November 19, 2019

Project 171.05027.008

Re: Nordic Aquafarms, Inc
Request for Additional Information (2)
File No. NAE-2019-01481

**Belfast Aquaculture Project
Wetland and Stream Impacts
Map 2 of 4 - November 8, 2019**

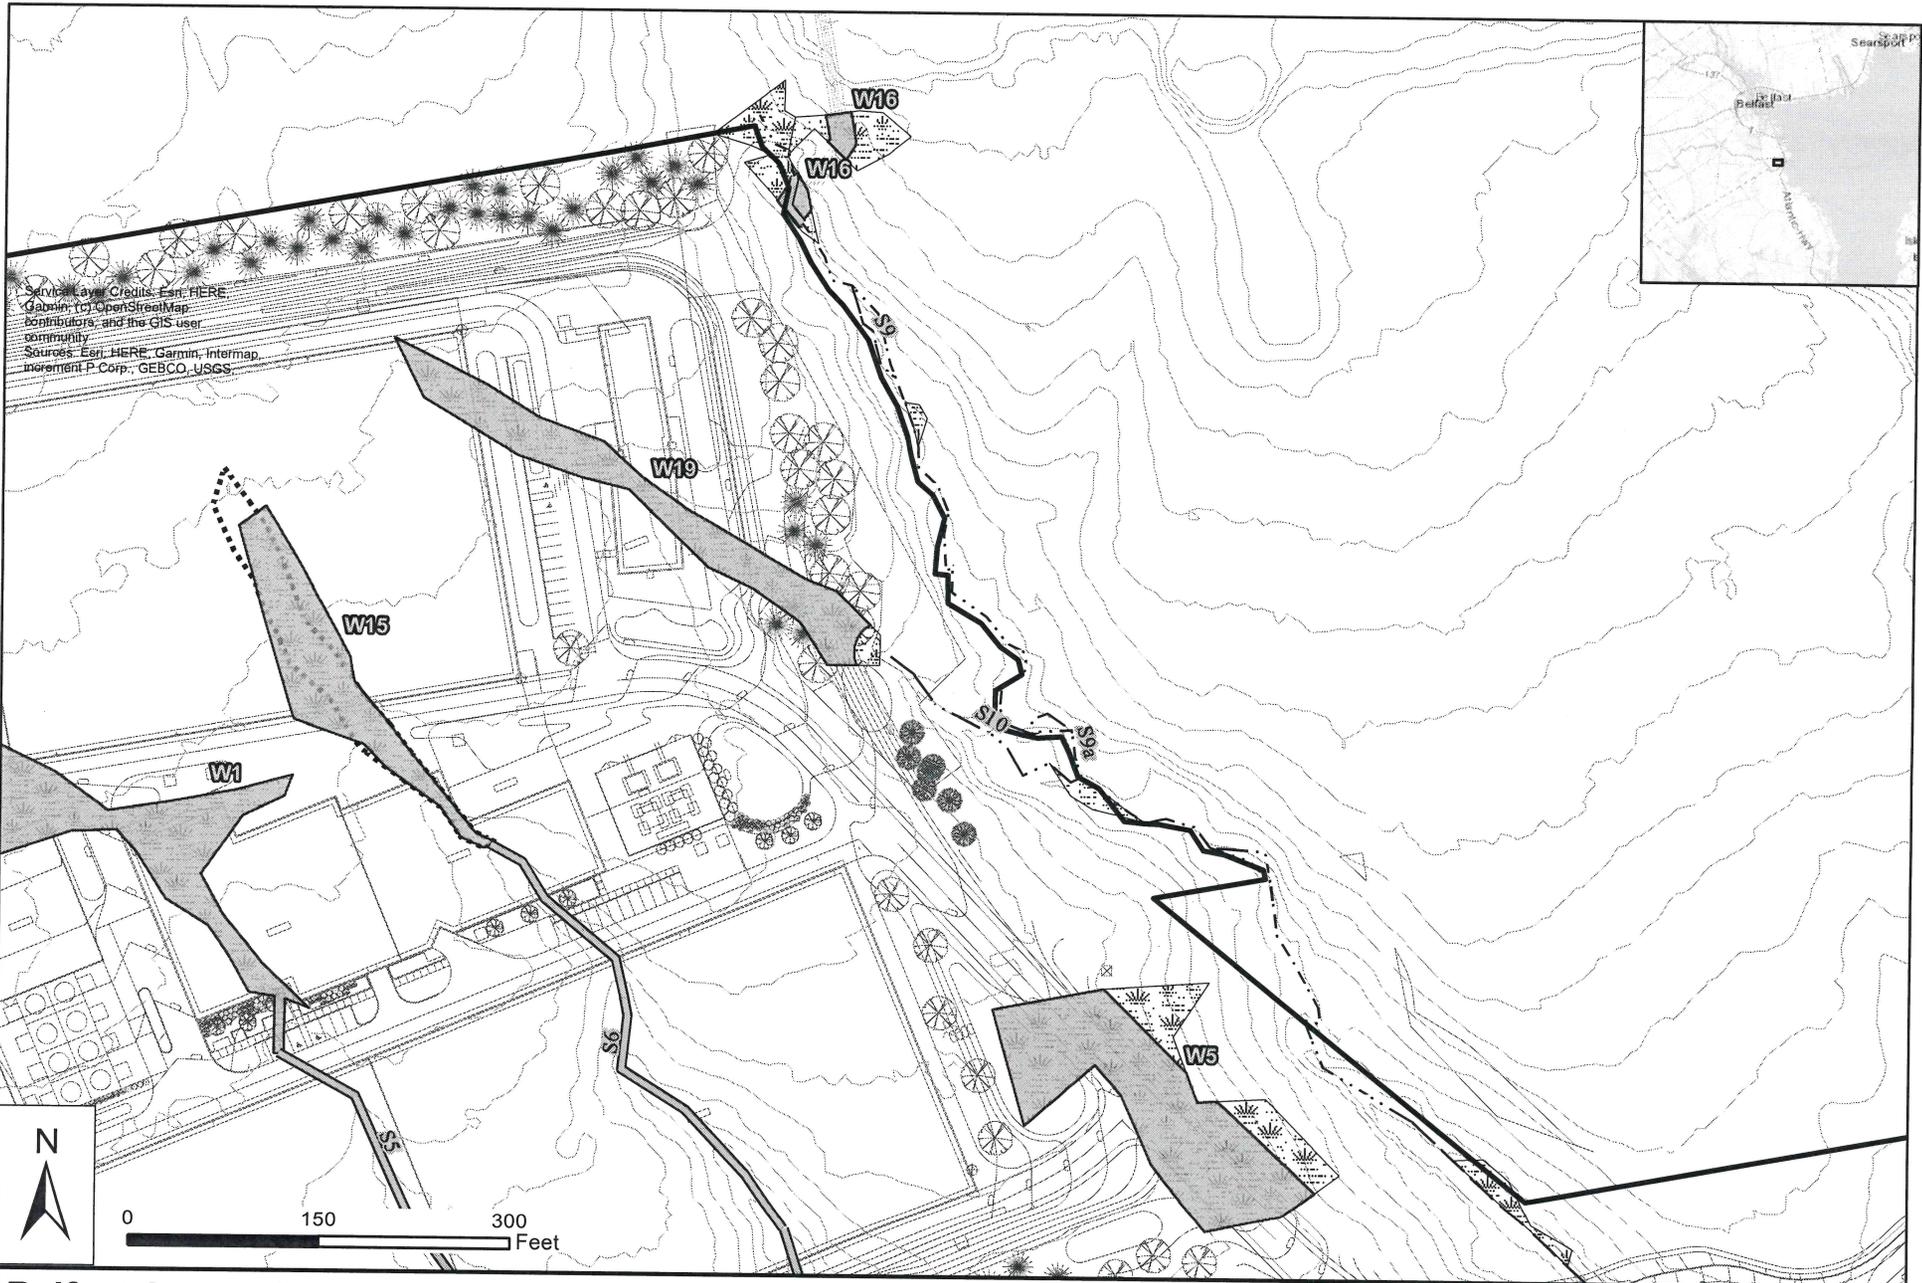
3. Attachment C. Sheet 1 of 2. This does not show the expanded W-16 wetland area. Was there impacts associated with the expanded area? Utility line? If not, does not have to be denoted on this Sheet.

The expanded W-16 wetland area was shown on the black and white drawing in Attachment C entitled “Wetland and Stream Survey” and shown in a cross hatched pattern. An updated set of Wetland and Stream Impacts maps reflecting the most recent site survey in October 2019 are attached to this submittal as Attachment 3. The planned domestic waste pipeline leading to City of Belfast sewer crosses W-16. The wetland impact area for this crossing is shown on Map 2 of 4

in Attachment 3. As noted on the revised text of Section 13.0 Compensation Plan also in Attachment 3, no permanent impacts to W-16 are proposed.

**Belfast Aquaculture Project
Wetland and Stream Impacts
Map 3 of 4 - November 8, 2019**

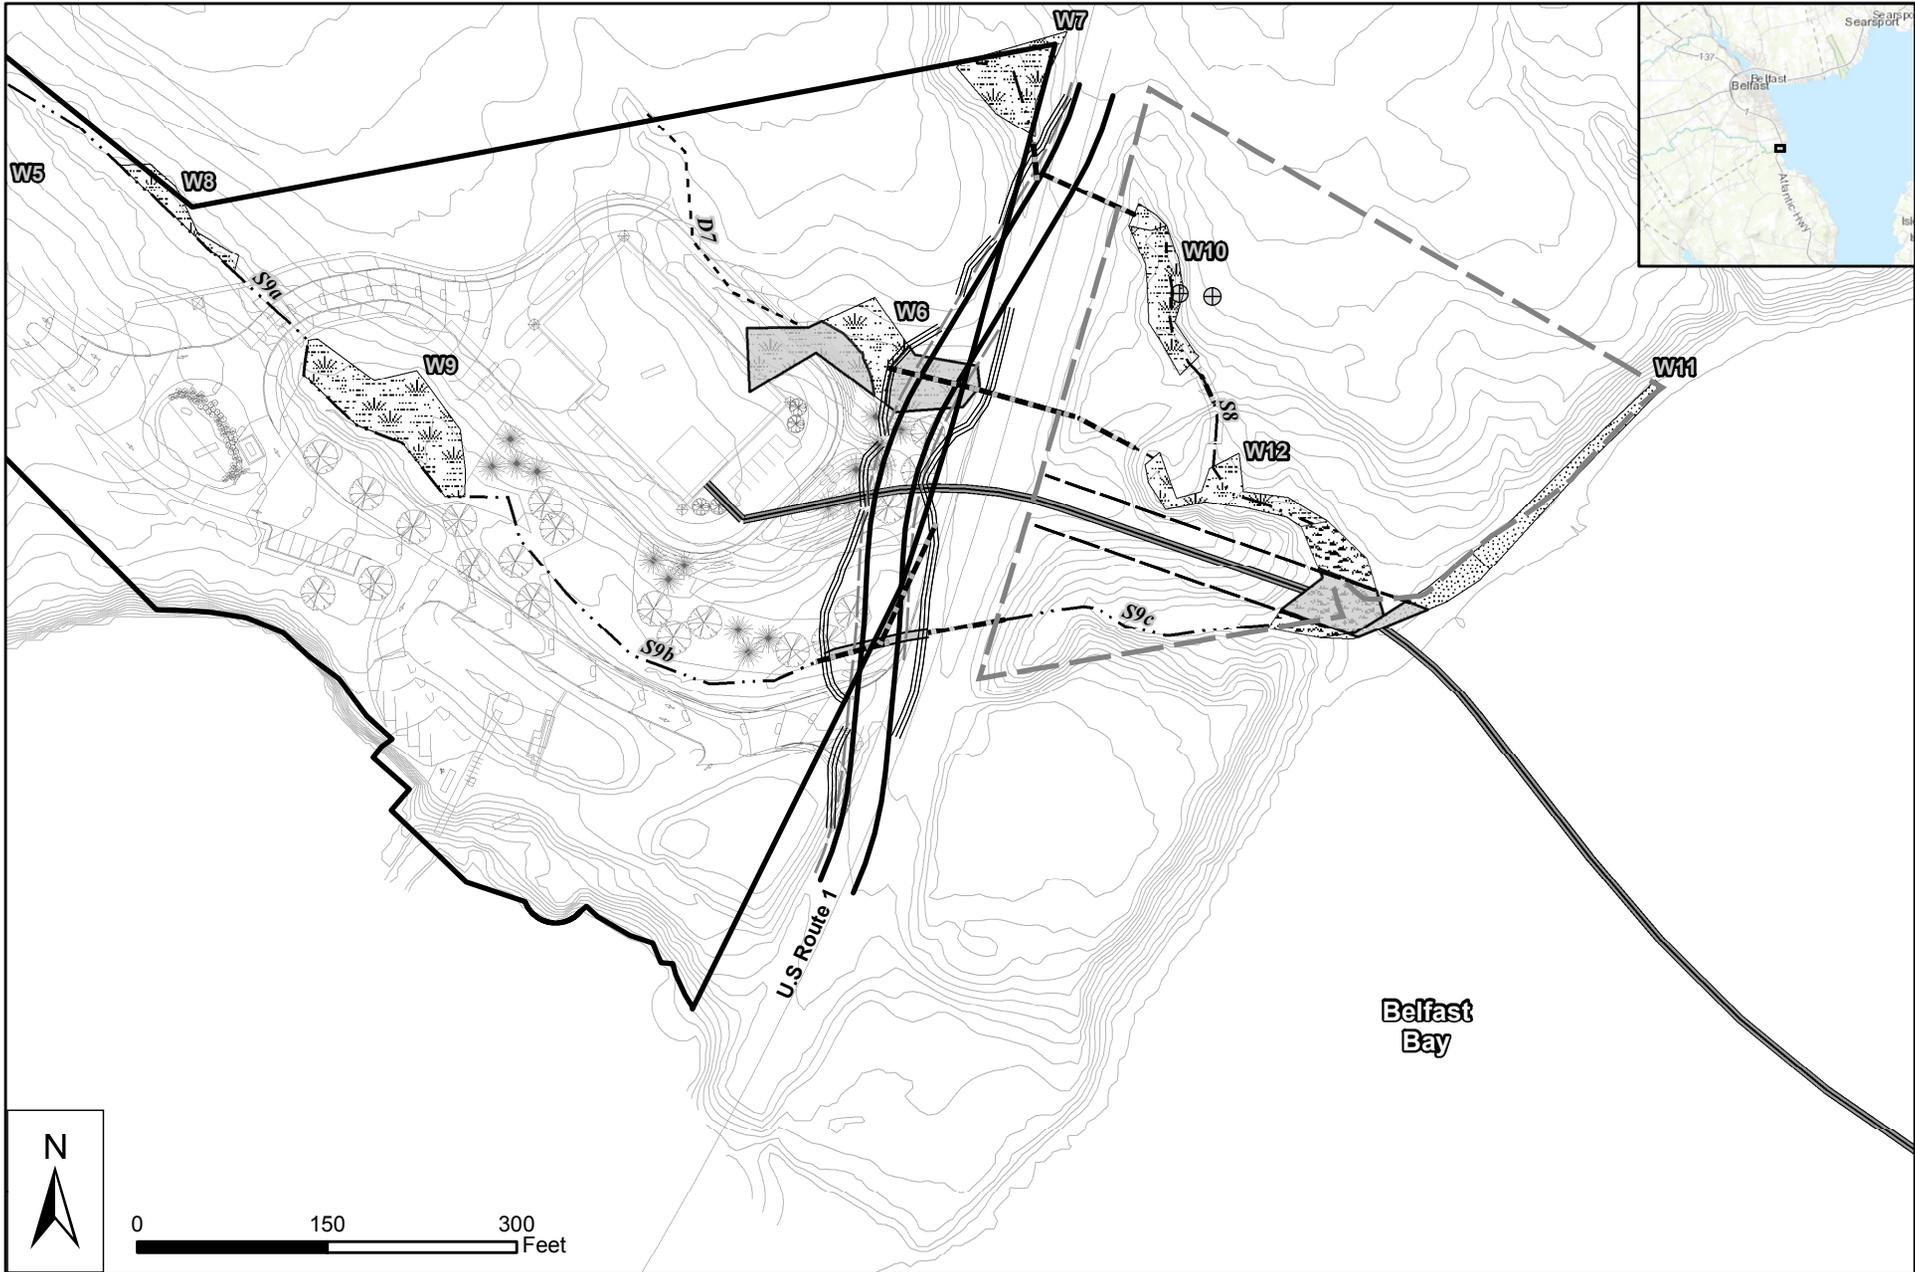
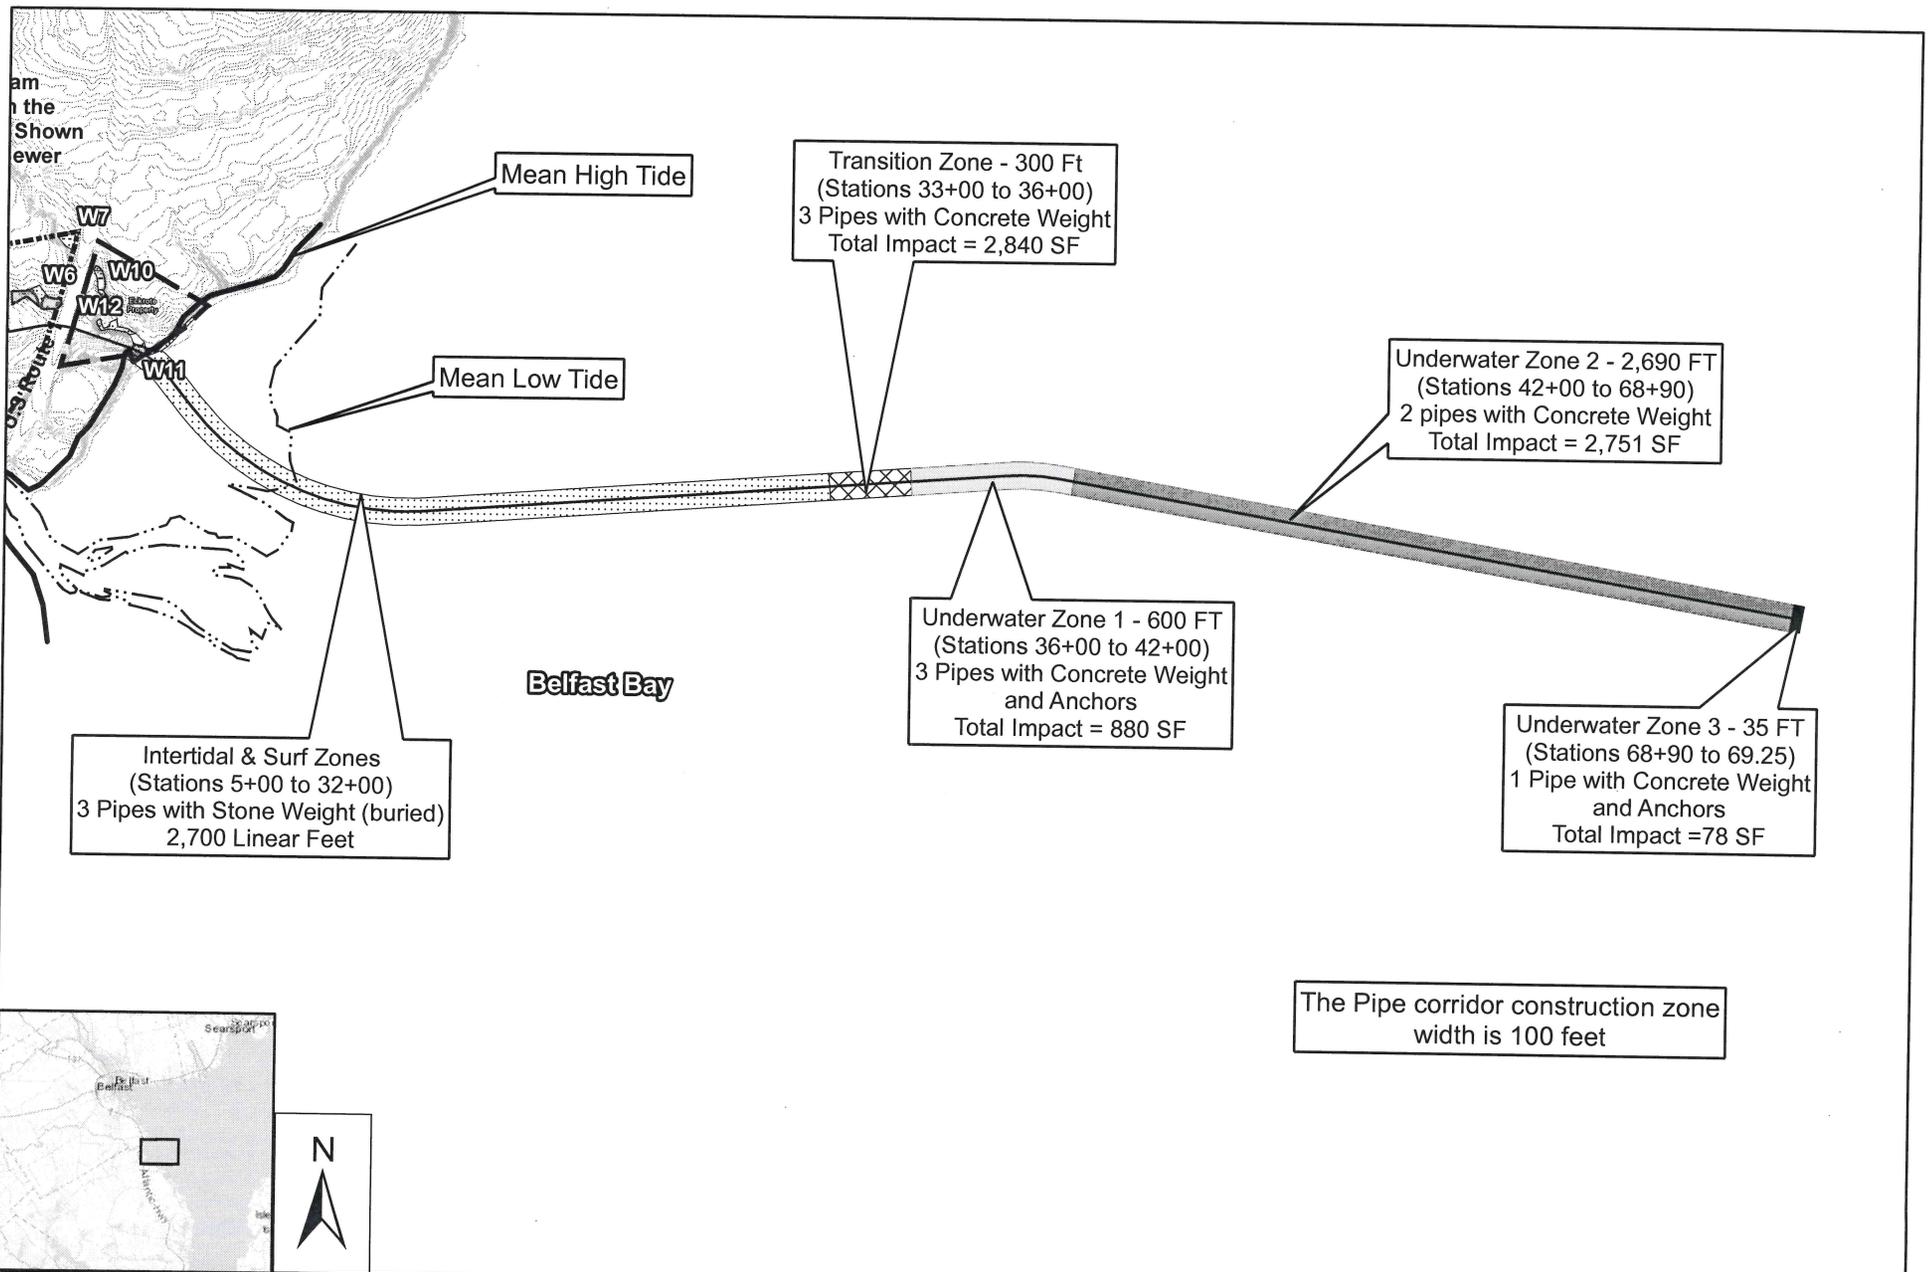
4. Attachment C. Sheet 2 of 2. This drawing needs to have the High Tide Line denoted since this is the tidal limits of our permitting jurisdiction for the “fill” work waterward of this line. Although there are small boxes as a legend for the tidal lines, I would add them directly to the respective plotted lines. I would add the nos. 1, 2, & 3 to the Underwater Zones so that the labelling synchs up with the Impact Table. Please add a linear footage of the line in the Intertidal/Surf Zone. Can a corridor width label be added somewhere along the alignment?

The Highest Annual Tide Line has been added to this figure, and the linear footage and width have been added as suggested. The revised wetland impact maps have been broken into four figures for clarity, which are attached to this submittal as Attachment 3. The intertidal and subtidal areas are shown on Maps 3 and 4 within Attachment 3.

Sheet No:
CC-101

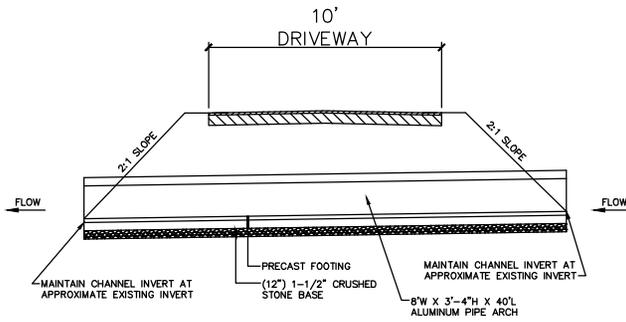
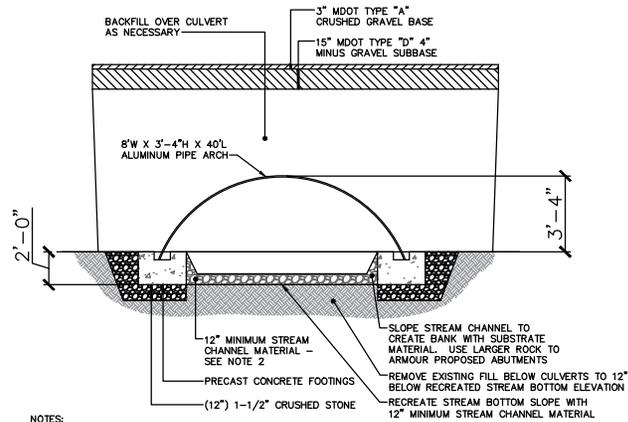
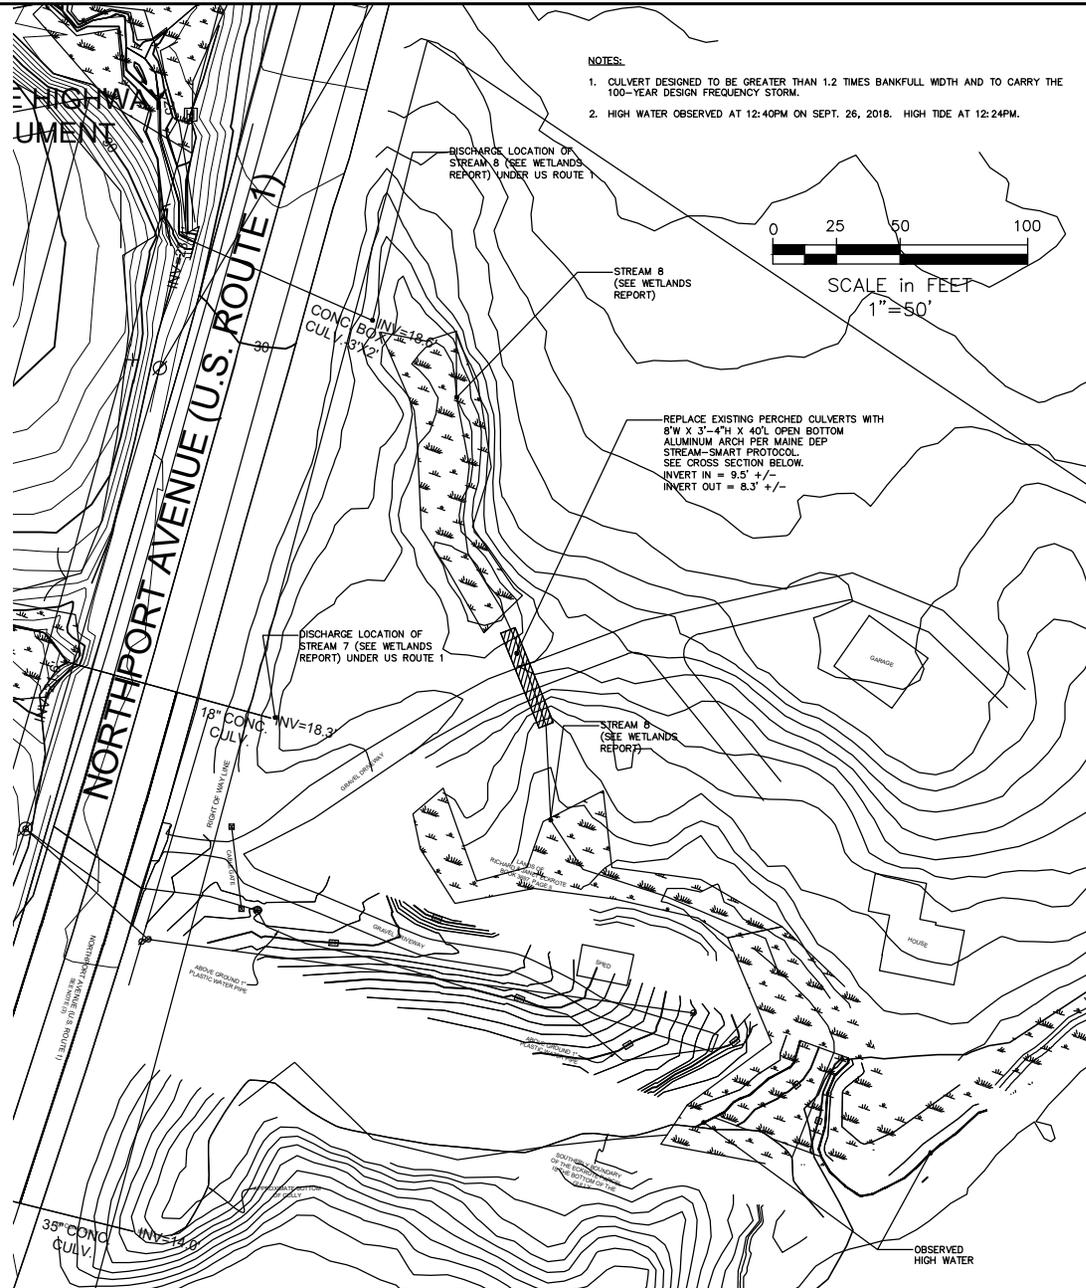
5. Attachment F. Sheet CC-101. Eckrote crossing. I need this reduced to 8 ½ x 11 like done for CG-201 (No. 9) and please denote the existing Ordinary High-Water Mark on the plan’s Cross Section insert.

7. For Stream Crossing 9 and the Eckrote culvert, if the stream bottom within the footprint of the culvert needs to be disturbed/excavated and then backfilled with imported “embed material” or “stream channel material” we consider that a permanent impact not temporary. Therefore, on the Impact Tables (Attachment E) I will need the temporary impacts for S8 & S9 moved over to the permanent column. I will need these revised impact amounts to go out on Public Notice. Note – Since the Eckrote culvert replacement is being done as part of the project’s compensation, the aforementioned permanent impact amount can be backed-out of an In-lieu fee calculation.

Impact compensation plans for the project are in Attachment 4. Culvert replacement locations are shown on Map 3. The reduced plan is attached as Attachment 5 for the replacement of the three hung culverts under the Eckrote driveway. There is a second, single, perched culvert under the Eckrote driveway that currently carries flows from D7 to its confluence with S8. This culvert will also be replaced with an open bottom aluminum arch similar to the attached as part of the project stream impact compensation package.

The Stream 9 crossing culvert is a box span that will have its supports outside of the existing stream channel banks, so no permanent impacts to the stream channel are anticipated. The Eckrote culvert will replace the existing perched culverts with an open bottom aluminum arch and recreate a stream bottom per Maine DEP Stream-Smart protocol. Since a true stream bottom does not exist within the footprint of the current perched culverts, no permanent impacts are
